Imray Correction Notice ICA301

Chart **A301** WGS 84

Edition 2006

Block correction for A301 (Plan B)
ILNW 453/18

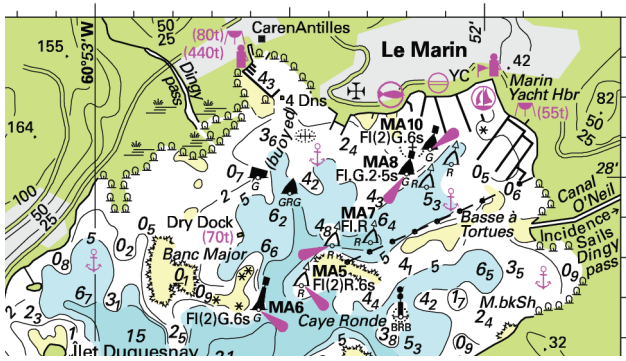
17 Cul-de-Sac Marin (Plan B)

Insert accompanying block correction centred on 14°27'·99N 60°52'·41W (Doyle/Street 9/2018) (ILNW 453/18)
